# **Pentium<sup>®</sup> II Processor Specification Update**

Release Date: June 1998

Order Number: 243337-015

The Pentium<sup>®</sup> II processor may contain design defects or errors known as errata which may cause the product to deviate from published specifications. Current characterized errata are documented in this Specification Update.

Figure 1. UP Dual Ended Termination (DET)

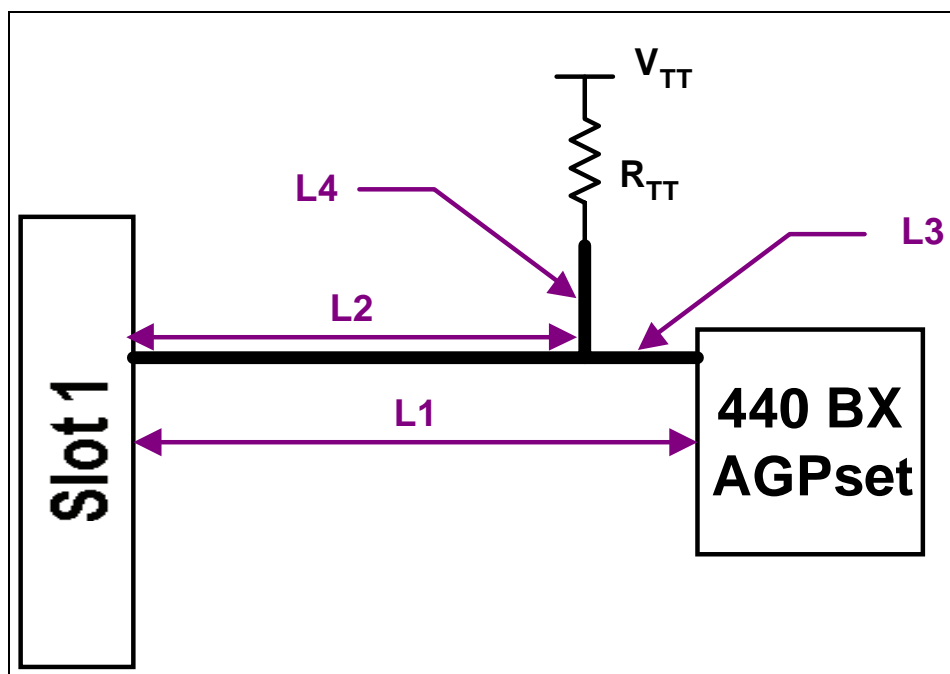
For UP-DET topologies (see Figure 1), the trace length  $L1$  must be between 1.5" to 4.5" while using a  $56\Omega$  termination resistor.

Figure 2. DP Dual Ended Termination (DET)

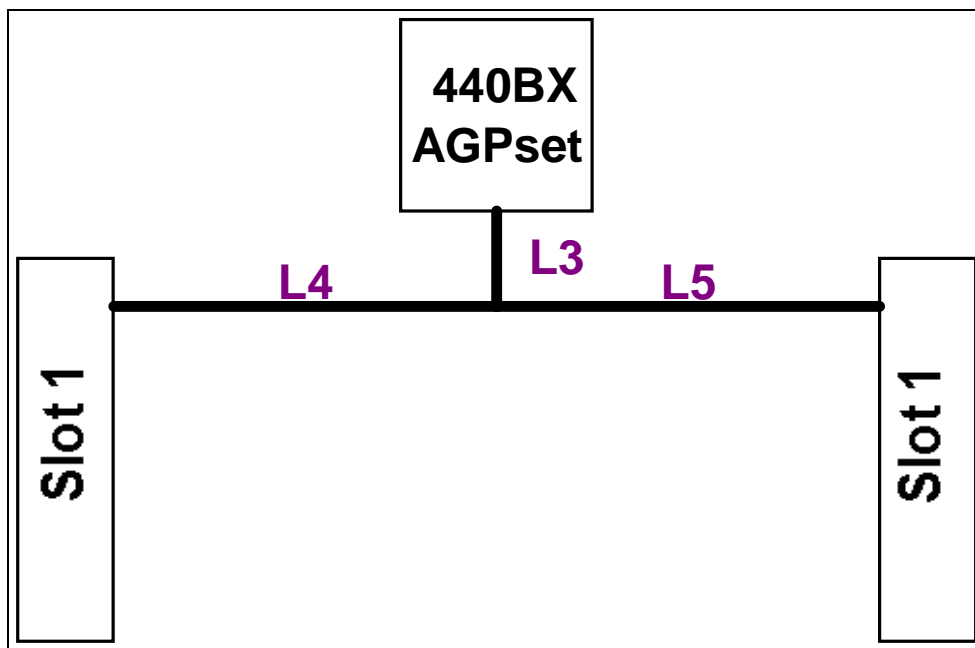
For DP topologies (see Figure 2) installed with a processor and a termination card,  $L4 + L3$  or  $L5 + L3$  must be less than or equal to 4.5". Additionally, for DP platforms with one processor installed, the termination card should be placed in the longer leg.

#### **47.      *Test Pin Must be High During Power Up***

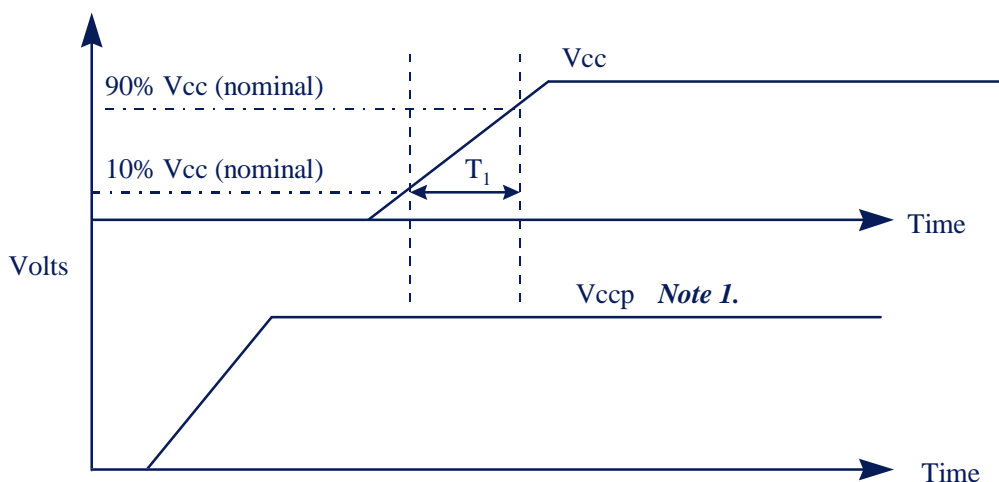
**PROBLEM:** The processor uses the PWRGOOD signal to ensure that no voltage sequencing issues arise; no pin assertions should cause the processor to change its behavior until this signal is asserted, when all power supplies and clocks to the

processor are valid and stable. However, if the TESTHI signal is at a low voltage level when the core power supply comes up, it will cause the processor to enter an invalid test state.

**WORKAROUND:** Ensure that the 2.5 V ( $V_{CC2.5}$ ) power supply ramps at or before the 2.0 V ( $V_{CCCORE}$ ) power plane. If 2.5 V ramps after core, pull up TESTHI to 2.5 V ( $V_{CC2.5}$ ) with a 100K ohm resistor. The internal pull-up will keep the signal from being asserted during power up. For new motherboard designs, it is recommended that TESTHI be pulled up to 2.0 V ( $V_{CCCORE}$ ) using a 1K-10K ohm resistor.

**Figure 4. An Example of Micro-controller Driven Thermal Management**

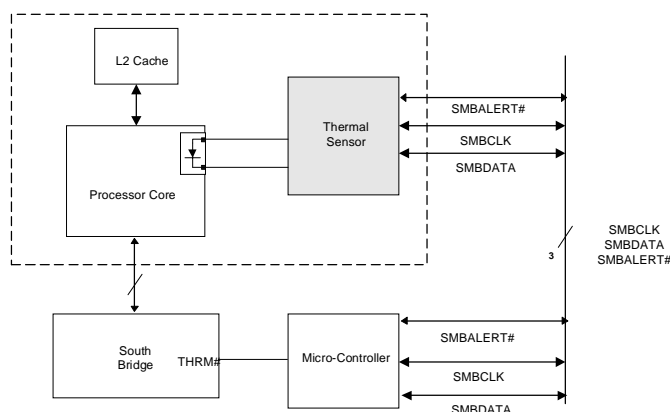
**PROBLEM:** The Mobile Pentium II processor and the Pentium II processor Mobile Module have a thermal sensor that monitors the processor core's temperature. Please note that desktop systems could have a similar thermal device. The thermal sensor asserts SMBALERT# if the processor temperature exceeds the temperature limits set in the Alarm Threshold Registers ( $T_{HIGH}$ ,  $T_{LOW}$ ). It also sets the corresponding Status Register bits to identify the cause of the interrupt. Figure 4 gives one example of the how the SMBALERT# signal could be used in a system.

Under the conditions described below, the thermal sensor incorrectly generates the SMBALERT# interrupt. **All** of the following conditions must be met to trigger a false interrupt:

**Figure 5. Workaround Flowchart: SMBALERT#-Driven System**

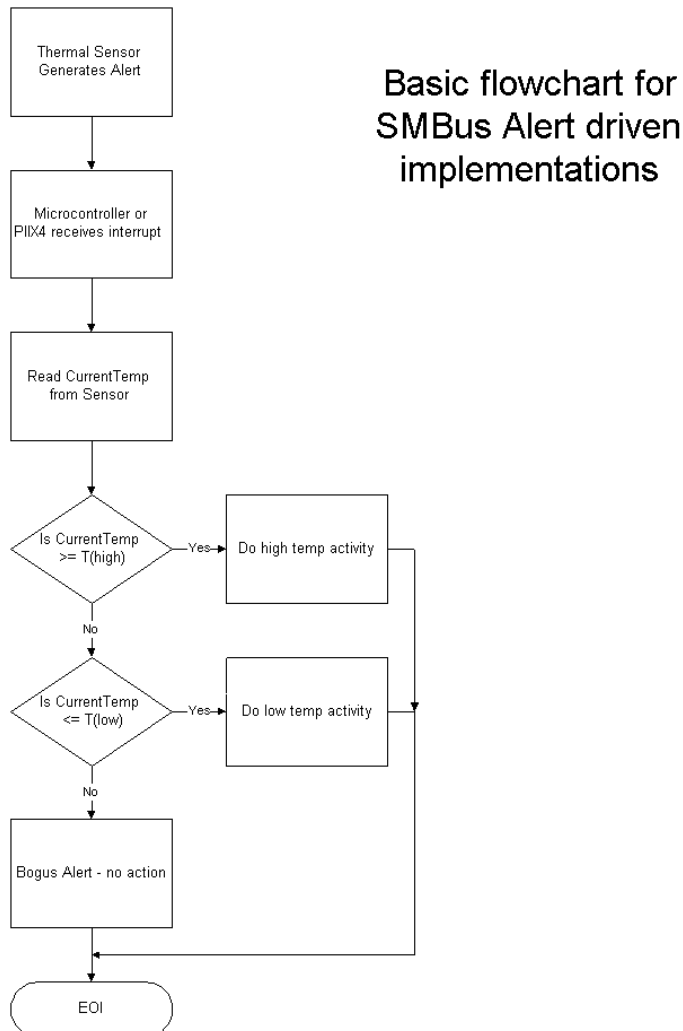
1. Before servicing an interrupt from the thermal sensor, read and compare the processor thermal reading with the threshold limits ( $T_{HIGH}$  or  $T_{LOW}$ ). Figures 5 and 6 provide basic flowcharts for the implementation of this workaround in an interrupt driven system.
2. If the firmware implemented polls the Status Register only, then before taking any action, re-read the temperature register and do a comparison with the alarm

**Figure 23. Processor with an Example Low Profile Heatsink Attached Using Spring Clips**

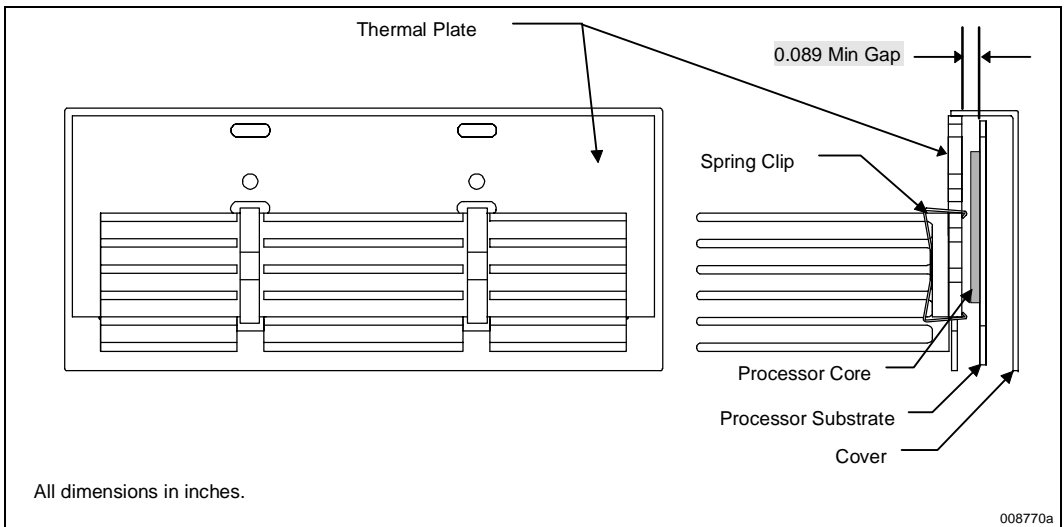
Figure 23 and Figure 24 illustrate example clip designs to support a low profile and a full height heatsink, respectively. The clips attach the heatsink by engaging with the underside of the thermal plate. The clearance of the thermal plate to the internal processor substrate is a minimum **0.089"** (illustrated in Figure 23 and Figure 24). The clips should be designed such that they will engage within this space, and also not damage the substrate upon insertion or removal. Finally, the clips should be able to retain the heatsink onto the thermal plate through a system level mechanical shock and vibration test. The clips should also apply a high enough force to spread the interface material for the spot size selected.

Figure 26. Heatsink Rivscrew\* and Thermal Plate Recommendations and Guidelines

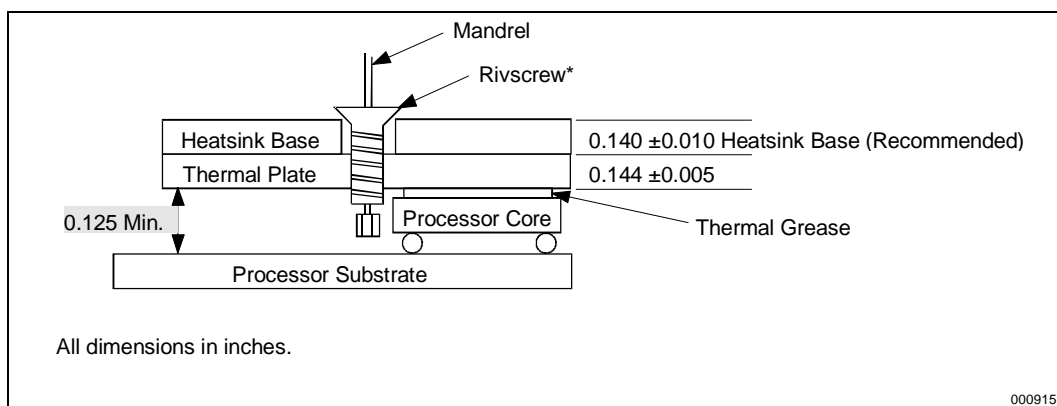
The Rivscrew attach mechanism uses a specialized rivet that is inserted through a hole in the heatsink into the thermal plate. Upon insertion, a threaded fastener is formed that can be removed if necessary. For Rivscrew attachment, the minimum gap between the thermal plate and the processor substrate is **0.125"**. For use of the Advell Rivscrew (part number 1712-3510), the heatsink base thickness must be  $0.140 \pm 0.010"$ . See Figure 25, Figure 26 and Figure 27 for details of heatsink requirements for use with Rivscrews.
